DESIGNED MCP	REVISED - ADDENDUM A 02/22/2013	<b>STATE OF ILLINOIS DEPARTMENT OF TRANSPORTATION</b>	<b>LIGHTING PLANS - ILLINOIS ROUTE 59</b>		F.A.P. RTE. 338	SECTION (112 & 113) WRS-6	COUNTY DUPAGE	TOTAL SHEETS 734	SHEET NO. 477	
DRAWN MLE	REVISED -		SCALE: AS SHOWN	SHEET NO. 1 OF 8 SHEETS	STA. TO STA.	<b>LT-06</b>		CONTRACT NO. 60R31		
CHECKED MCP	REVISED -		ILLINOIS FED. AID PROJECT							
DATE 09/07/2012	REVISED -

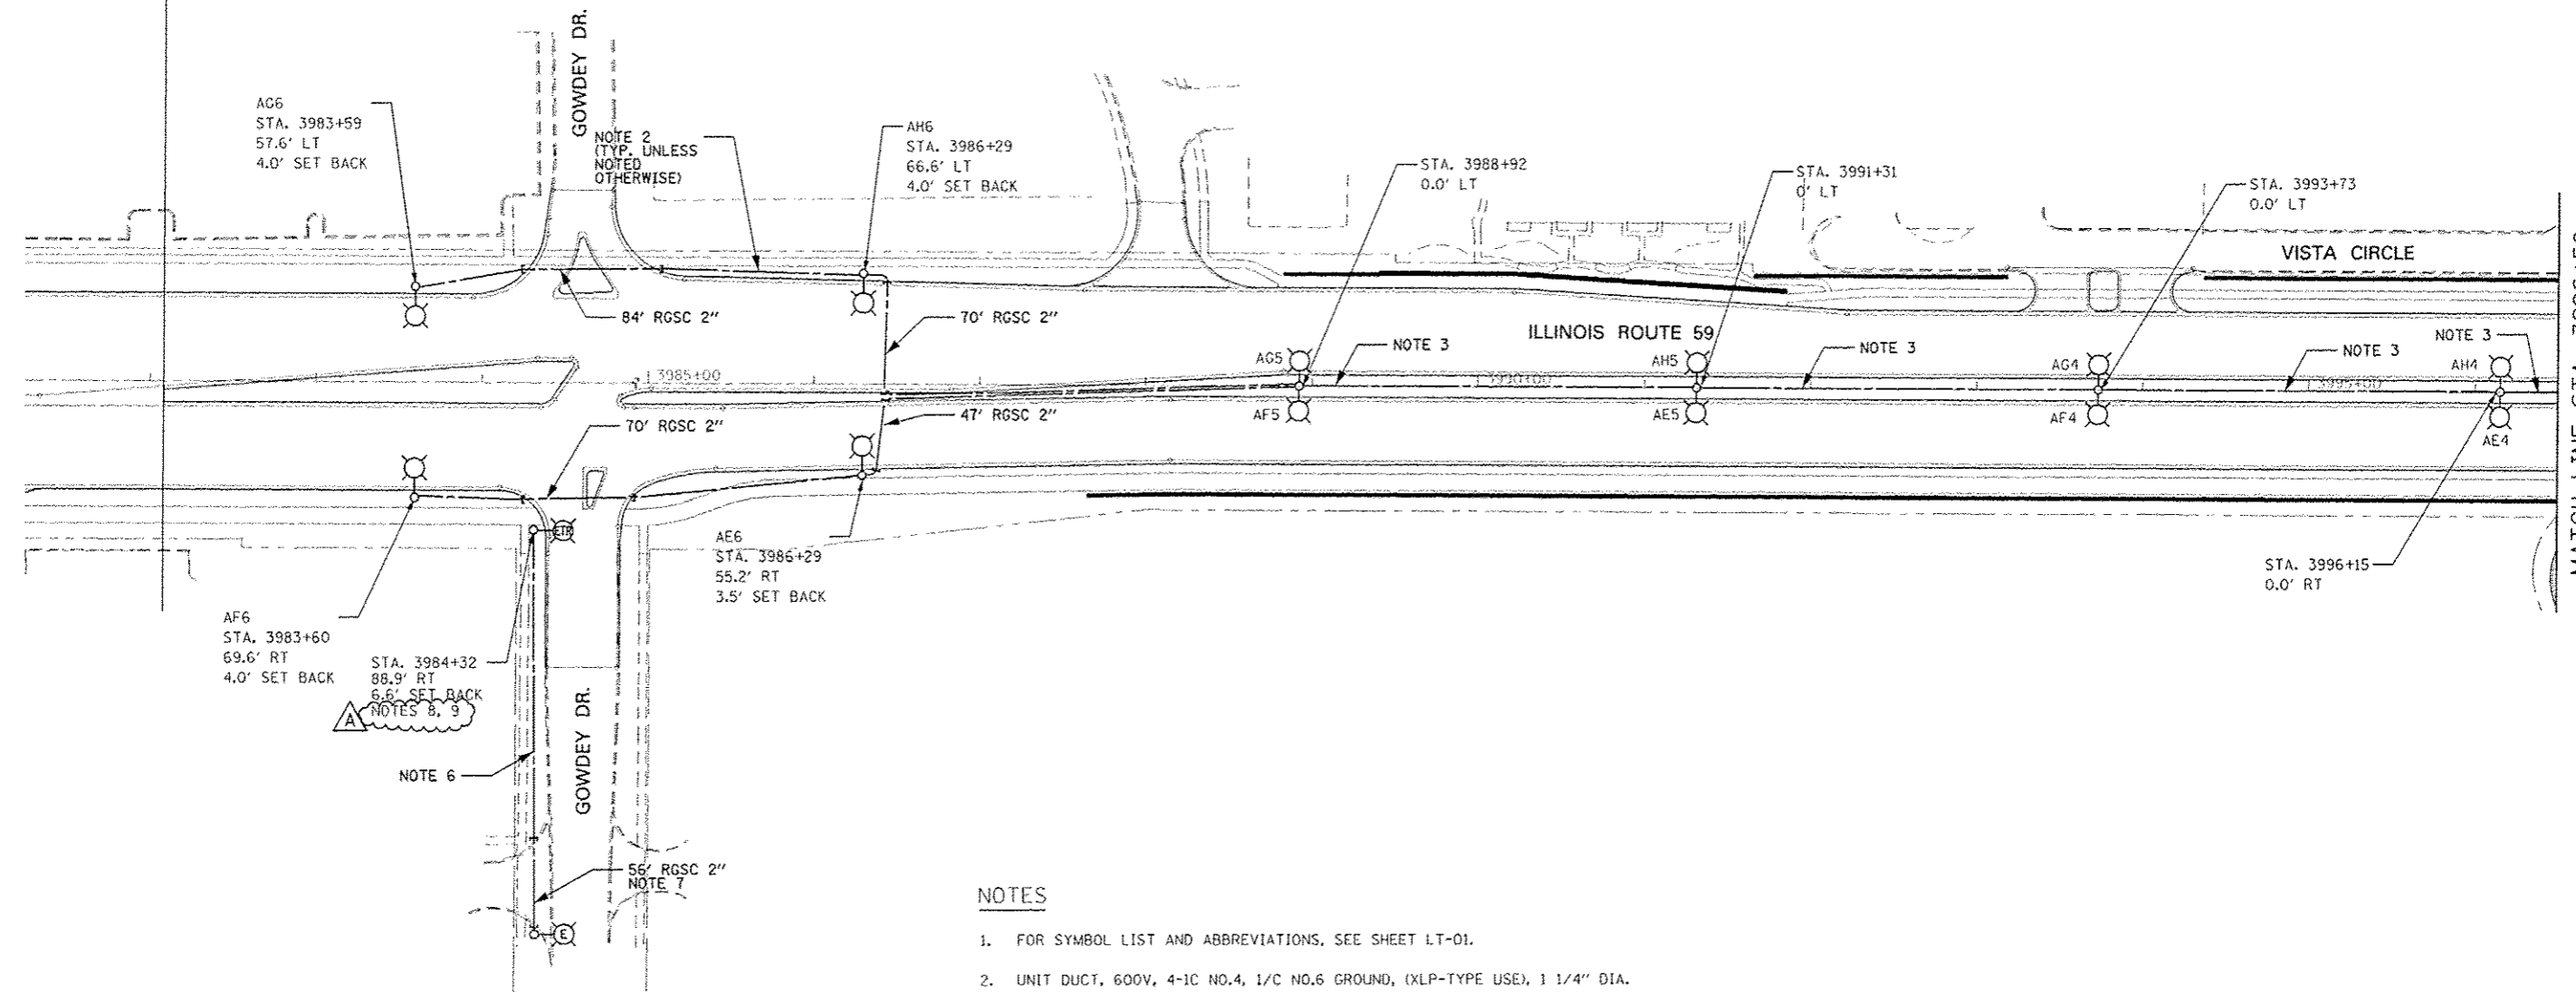
**A** POLE SHALL BE WIRED TO CITY OF NAPERVILLE CONTROLLER.

**A** BOLT CIRCLE AND ANCHOR BOLTS NUMBER AND LAYOUT OF THE FOUNDATION SHALL MATCH THE RE-INSTALLED POLE.
